**JOINT MEETING:**

**COMMISSION OF ARCHITECTURAL REVIEW  
&  
RIVER DISTRICT DESIGN COMMISSION**

**December 11, 2025  
3:30 PM**

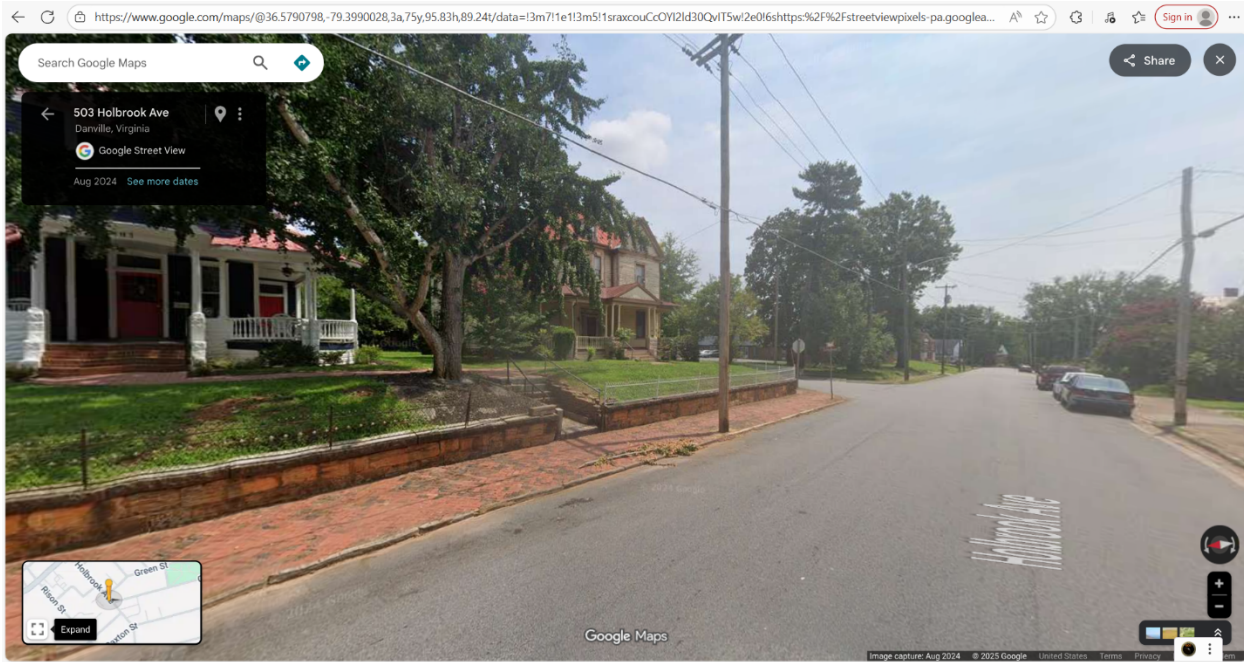
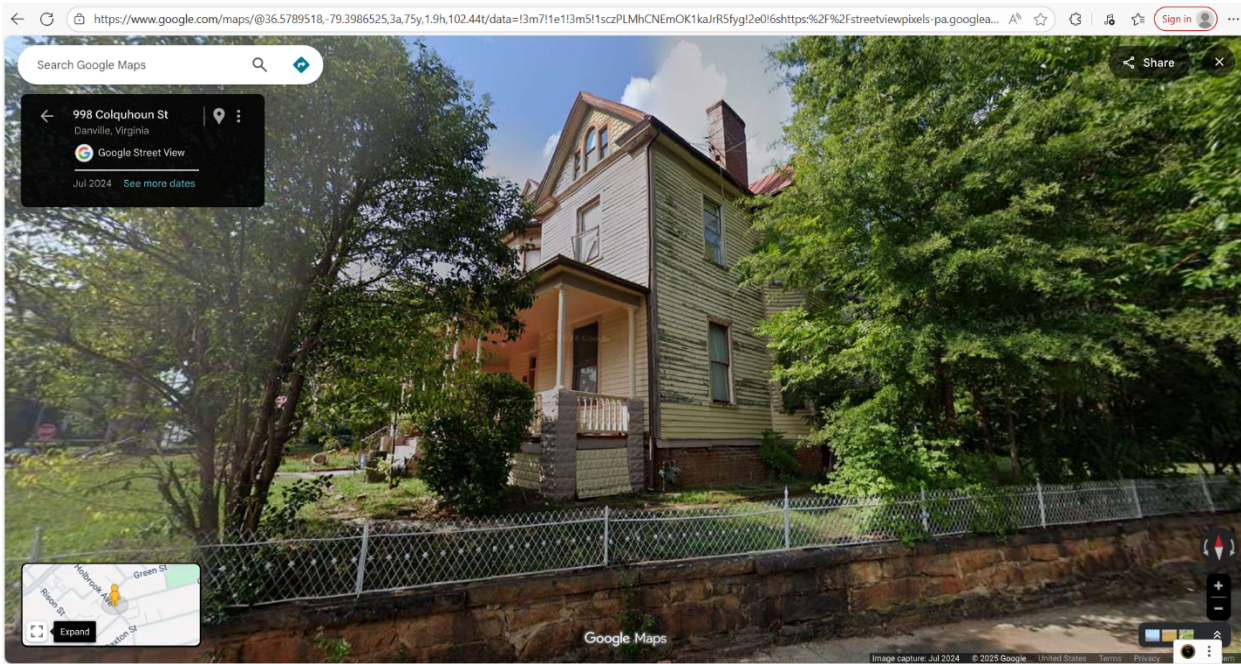
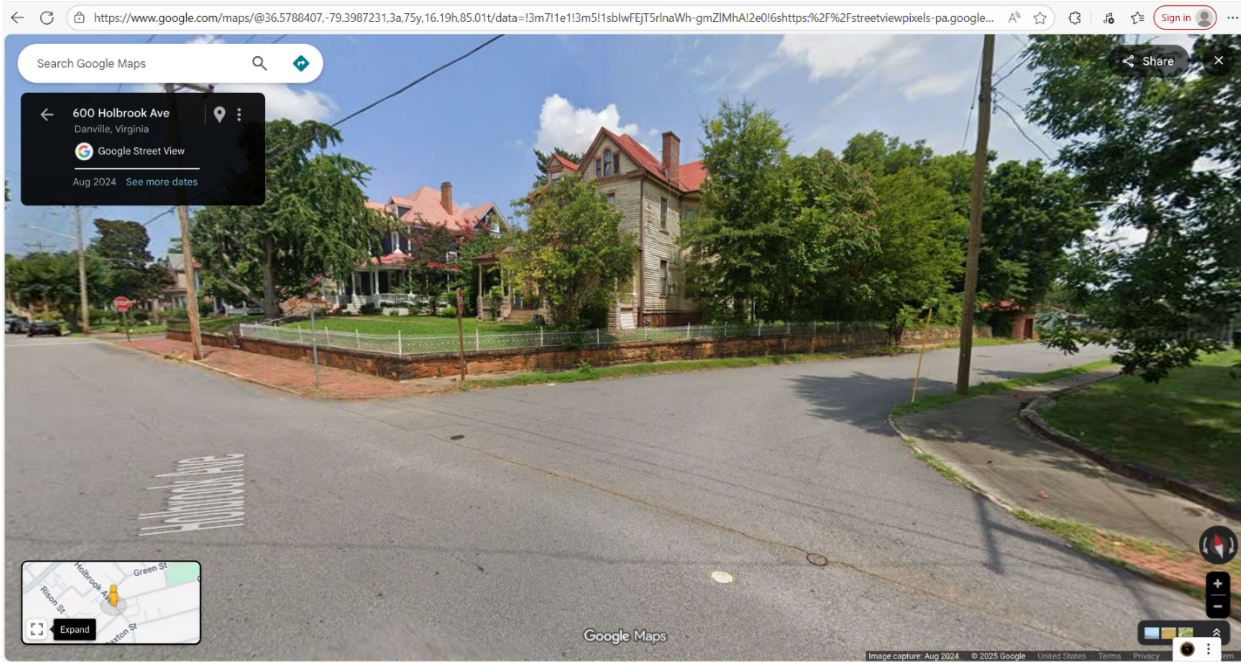
The applicant seeks a Certificate of Appropriateness to replace the existing sheet metal roof with a painted steel roof at 507 Holbrook Avenue. The proposed roof will be painted charcoal gray.

The Planning Division staff recommend approval of Certificate of Appropriateness application PZ25-00583 to replace the roof at Parcel 20119 (507 Holbrook Avenue).

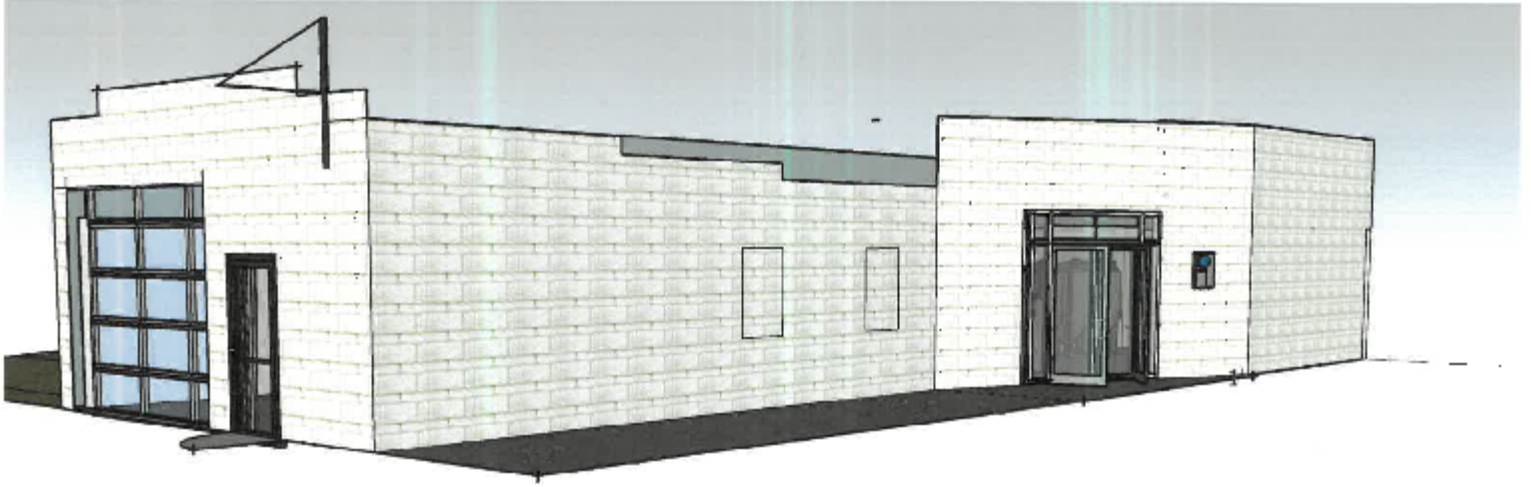
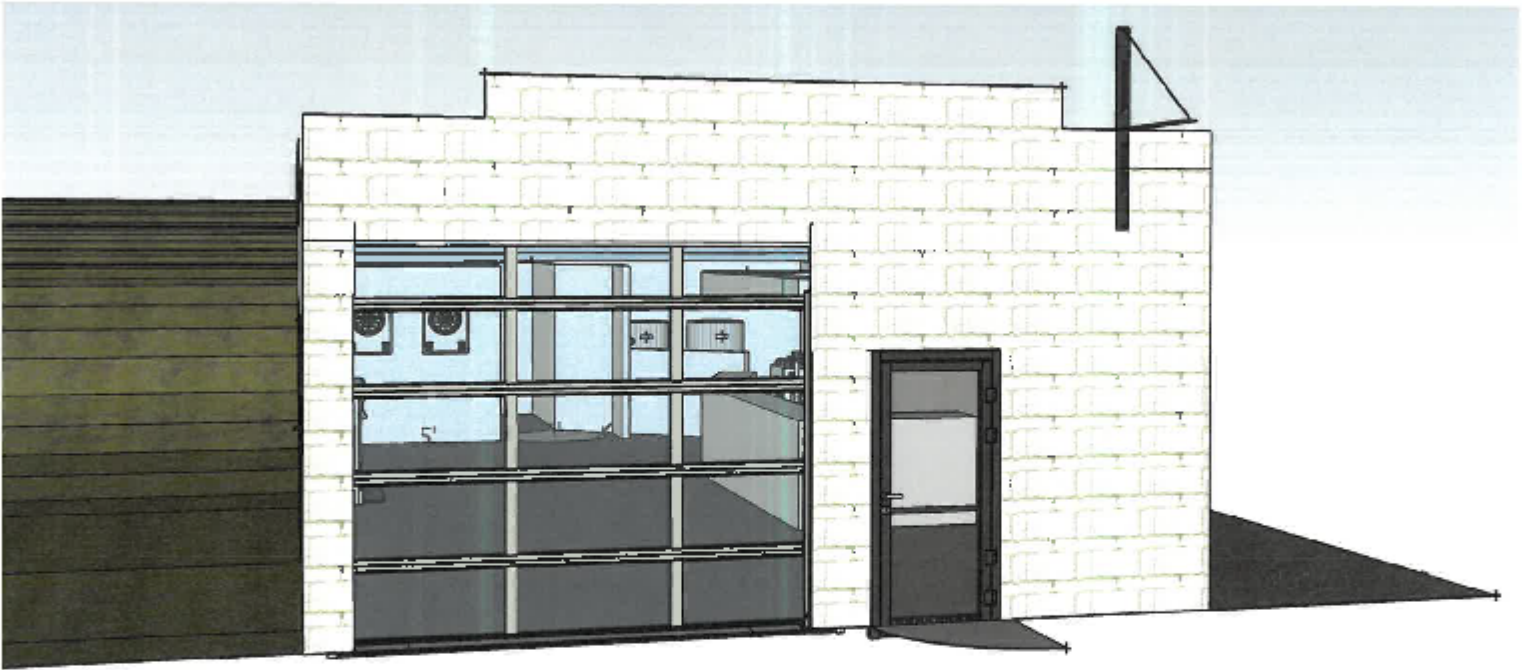
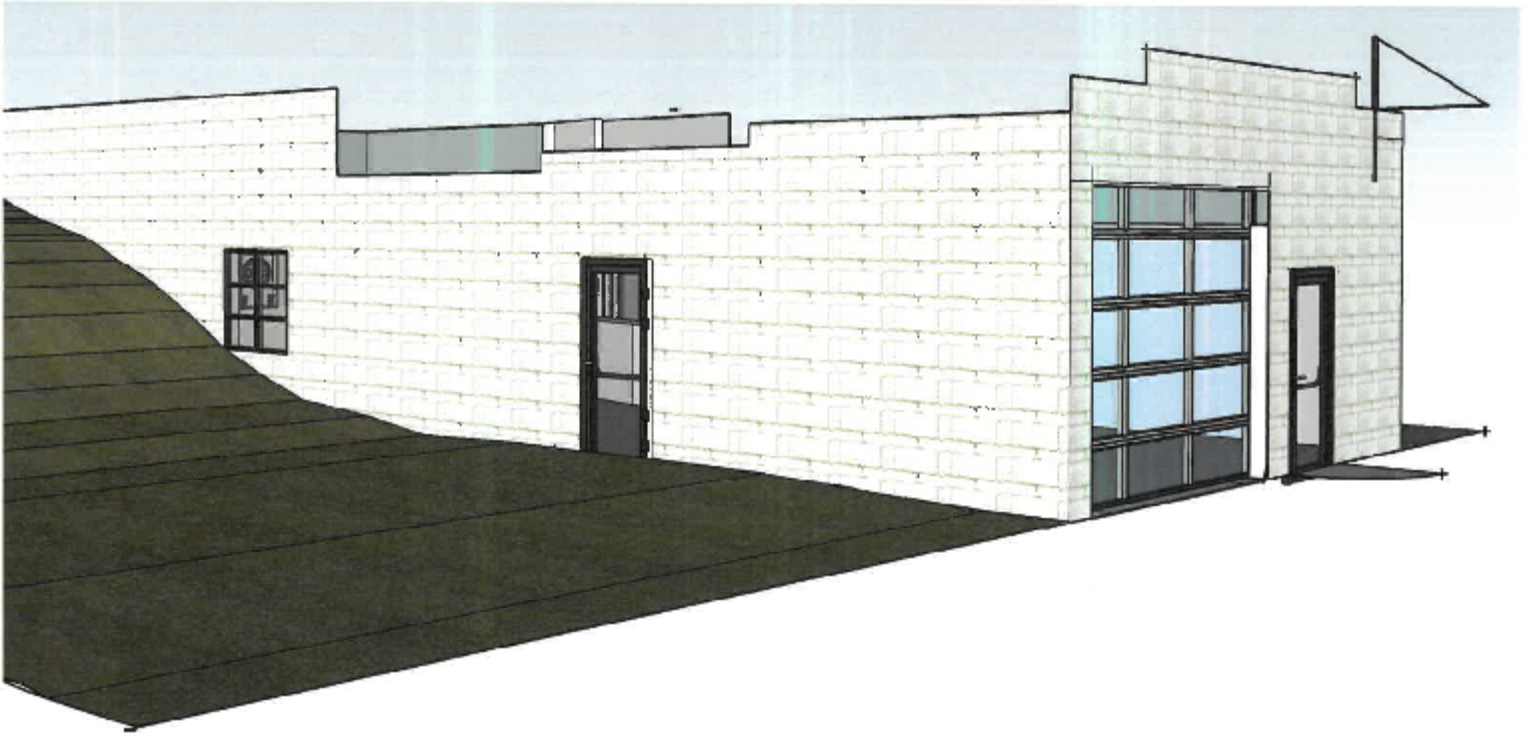
The applicant, James Buckner, is requesting to complete exterior changes to 592 Monument Street. The existing structure is a garage building that has remained largely unused. The proposed changes are as follows:

1. Replace solid garage door on front façade with glass door
2. Replace solid metal door with metal and glass storefront style door
3. Replace window on southern façade with new metal window
4. Replace window on southern façade with new metal and glass storefront door
5. Remove 2 windows on northern façade and fill with block to match existing wall
6. Replace solid garage door on northern façade with metal and glass store style entry and door, including glass sidelights and glass transom
7. Install projecting sign on existing sign pole, painted sign above garage door, and painted mural on side wall of building

The Planning Staff recommends approval of PZ25-00600. The replacements presented use materials and styles to maintain the industrial character of the structure. The proposed changes provide an attractive appearance for future commercial use.
